SUBJECT: AMENDMENT NO. 69 TO FACILITY OPERATING LICENSE NO. NPF-3;  
CYCLE 4 CORE REVISED OPERATING LIMITS

DAVIS-BESSE NUCLEAR POWER STATION, UNIT NO. 1

Amendment No. 69  
License No. NPF-3

SAFETY EVALUATION BY THE OFFICE OF NUCLEAR REACTOR REGULATION  
SUPPORTING AMENDMENT NO.69 TO FACILITY OPERATING LICENSE NO. NPF-3

Figure 3.1-2e. Regulating Group Position Limits,  $200 \pm 10$  to  $280 \pm 10$  EFPD, Four RC Pumps, APSRs, Withdrawn — Davis-Besse 1, Cycle 4

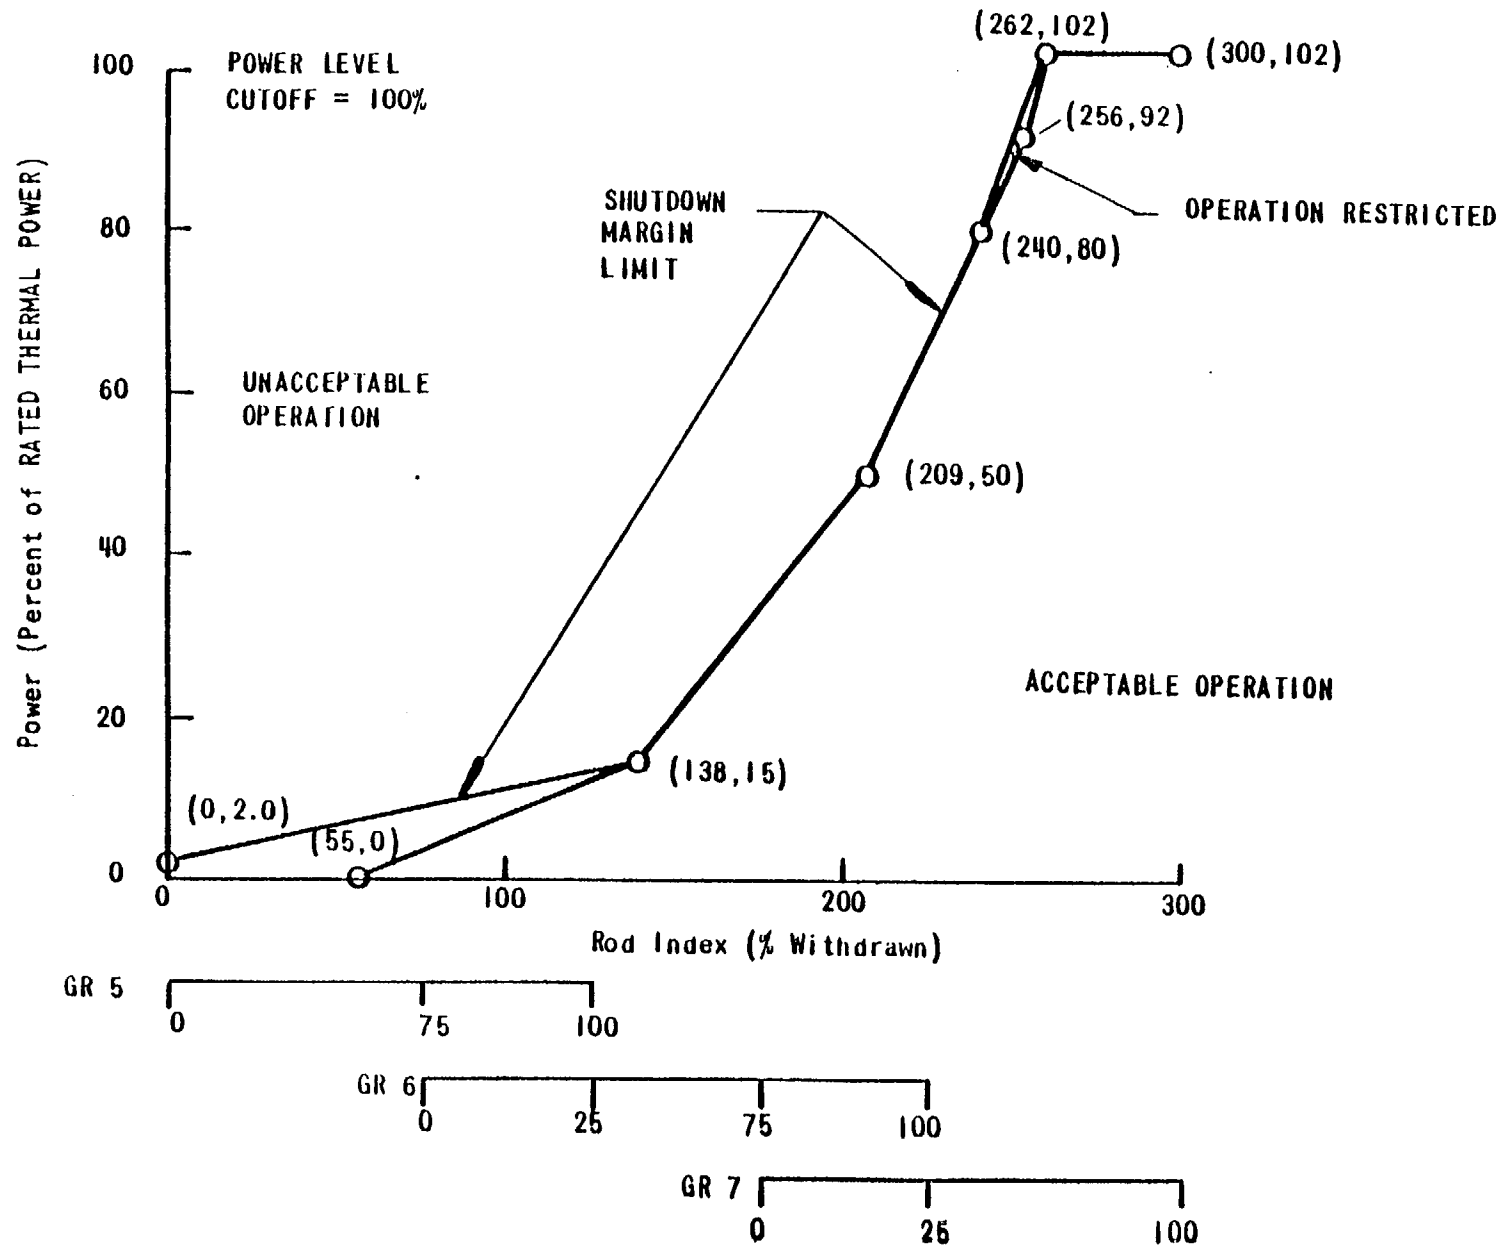
3.1.3.6 The regulating rod groups shall be limited in physical insertion as shown on Figures 3.1-2a, -2b, and -2c and 3.1-3a, -3b, and -3c for the first  $200 \pm 10$  EFPD of operation. If the axial power shaping rods are completely withdrawn at  $200 \pm 10$  EFPD for extension of cycle length, then the regulating rod groups shall be limited in physical insertion as shown on Figures 3.1-2e and 3.1-3e for the remainder of the cycle. However, if the axial power shaping rods are not completely withdrawn at  $200 \pm 10$  EFPD, then the regulating rod groups shall be limited in physical insertion as shown on Figures 3.1-2d and 3.1-3d for the remainder of the cycle. A rod group overlap of  $25 \pm 5\%$  shall be maintained between sequential withdrawn groups 5, 6 and 7.

Figure 3.1-5e. APSR Position Limits,  $200 \pm 10$  to  $280 \pm 10$  EFPD,  
Three or Four RC Pumps, APSRs Withdrawn —  
Davis-Besse 1, Cycle 4

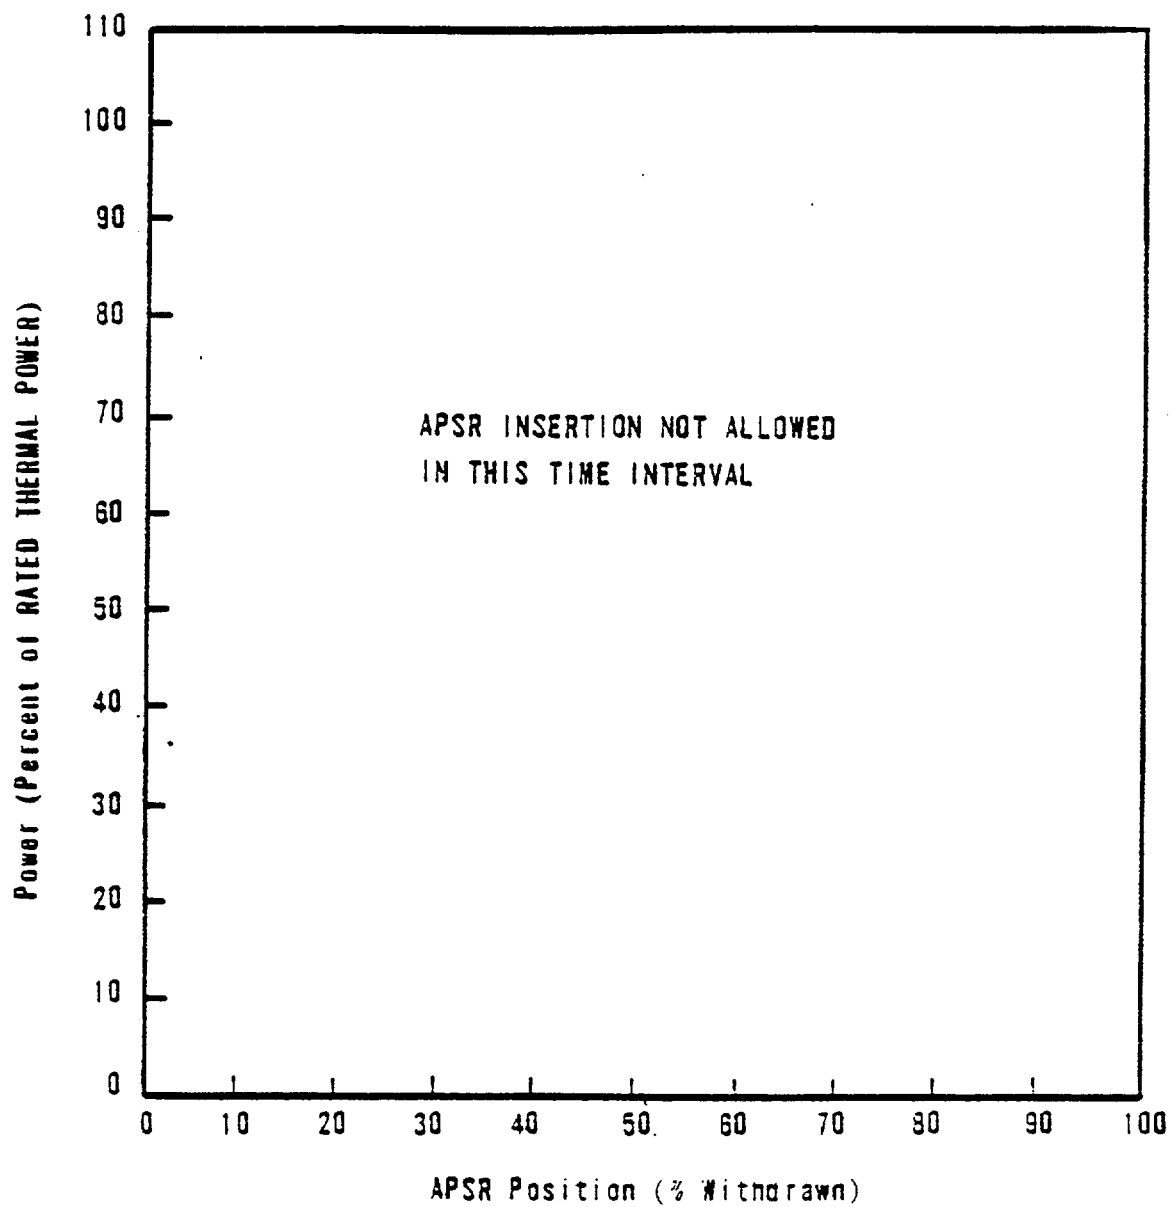
3.1.3.9 The axial power shaping rod group shall be limited in physical insertion as shown on Figures 3.1-5a, -5b, -5c, -5f, -5g and -5h for the first  $200 \pm 10$  EFPD of operation. If this rod group is completely withdrawn at  $200 \pm 10$  EFPD for extension of cycle length, it shall not be reinserted in the core for remainder of the cycle and the limits of Figure 3.1-5e shall be applicable. However, if the rod group is not completely withdrawn at  $200 \pm 10$  EFPD, the group shall be limited in physical insertion as shown on Figures 3.1-5d and -5i for the remainder of the cycle.

Figure 3.2-1e. Axial Power Imbalance Limits,  $200 \pm 10$  to  $280 \pm 10$  EFPD, Four RC Pumps, APSRs Withdrawn - Davis-Besse 1, Cycle 4

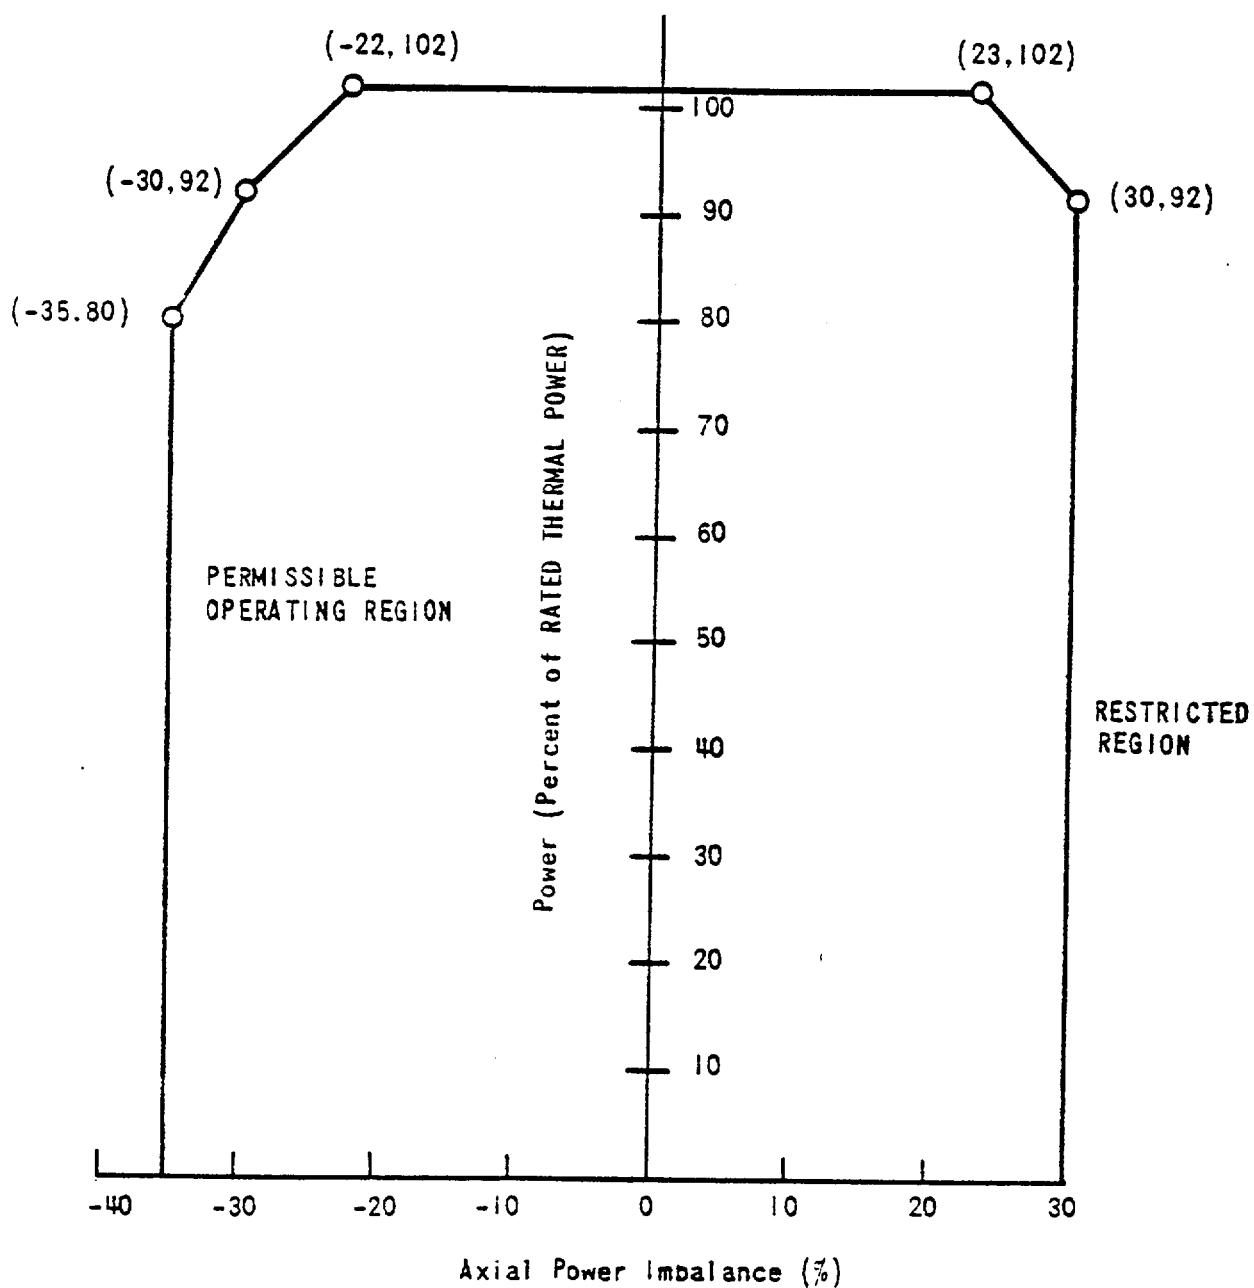
3.2.1 AXIAL POWER IMBALANCE shall be maintained within the limits shown on Figures 3.2-1a, -1b and -1c and 3.2-2a, -2b and -2c for the first 200  $\pm$ 10 EFPD of operation. If the axial power shaping rods are completely withdrawn at 200  $\pm$ 10 EFPD for extension of cycle length, then the AXIAL POWER IMBALANCE shall be maintained within the limits shown on Figures 3.2-1e and 3.2-2e for the remainder of the cycle. However, if the axial power shaping rods are not completely withdrawn at 200  $\pm$ 10 EFPD, then the AXIAL POWER IMBALANCE shall be maintained within the limits shown on Figures 3.2-1d and 3.2-2d for the remainder of the cycle.
